Informal Document No N:
(50th GRRF, 10-12 Sep. 2001,
agenda item 1.2.)
Original: ENGLISH

PROPOSAL FOR DRAFT AMENDMENTS TO REGULATION No. 13
(Braking)

Transmitted by the expert from the European Association
of Automobile Suppliers (CLEPA)
Representing the Informal Working Group for Modular Approval of Trailers

"Figure 1B

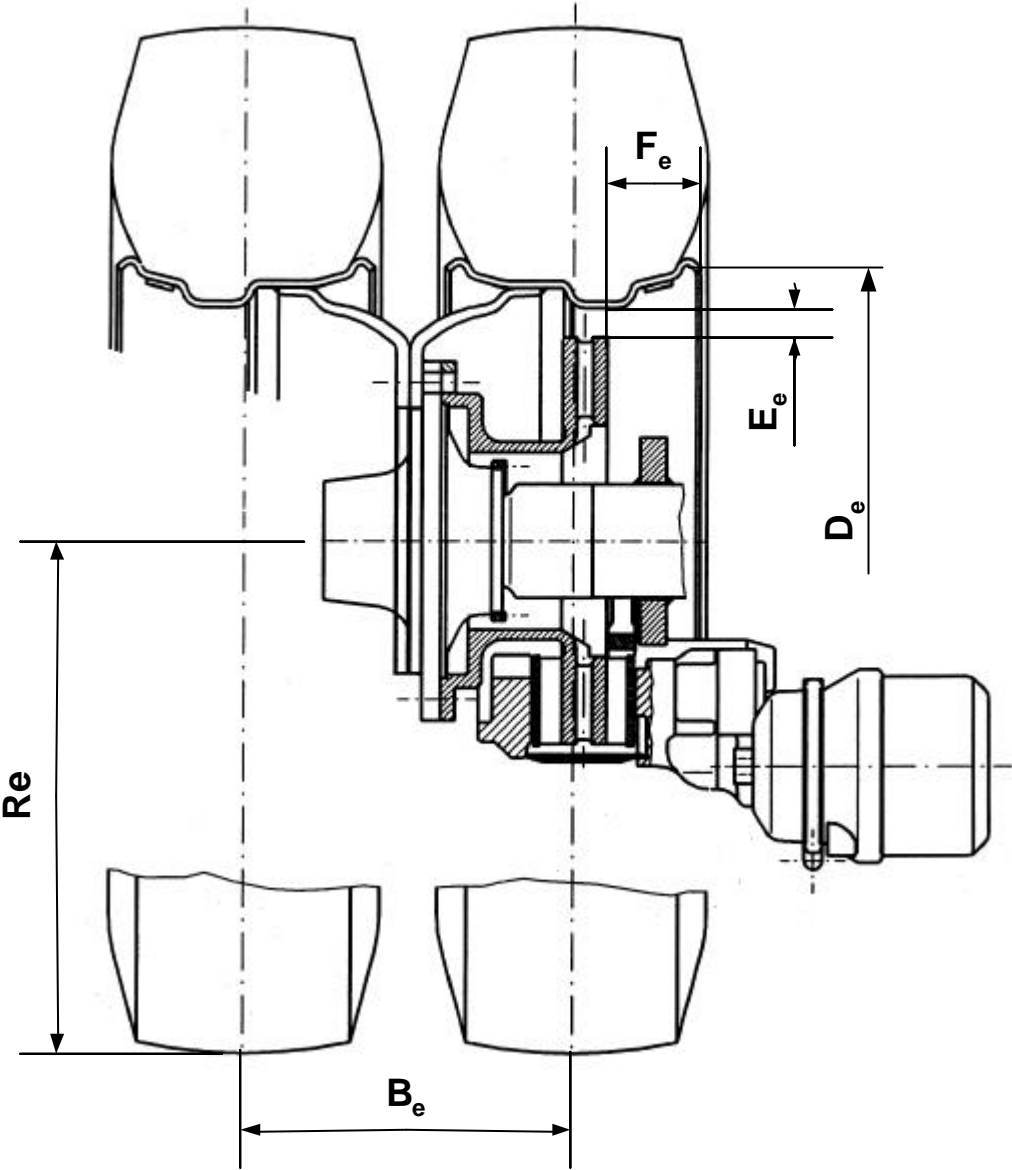
Insert a new Figure 1B for disc brakes, to read:

B_e (mm)	D_e (mm)	E_e (mm)	F_e (mm)	R_e (mm)

Figure 2B

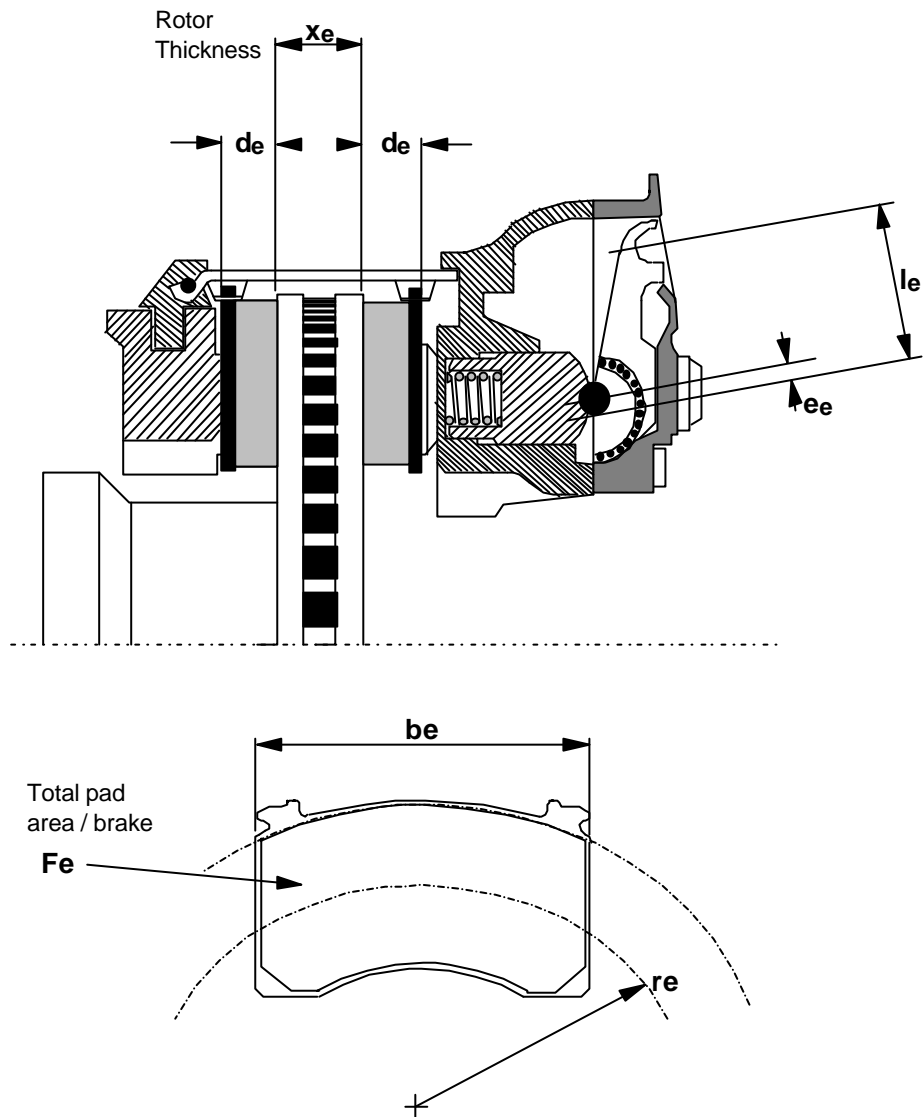
Figure 2, renumber as Figure 2A

Insert a new Figure 2B for disc brakes, to read:

l_e (mm)	e_e (mm)	d_e (mm)	x_e (mm)	r_e (mm)	b_e (mm)	F_e (cm ²)
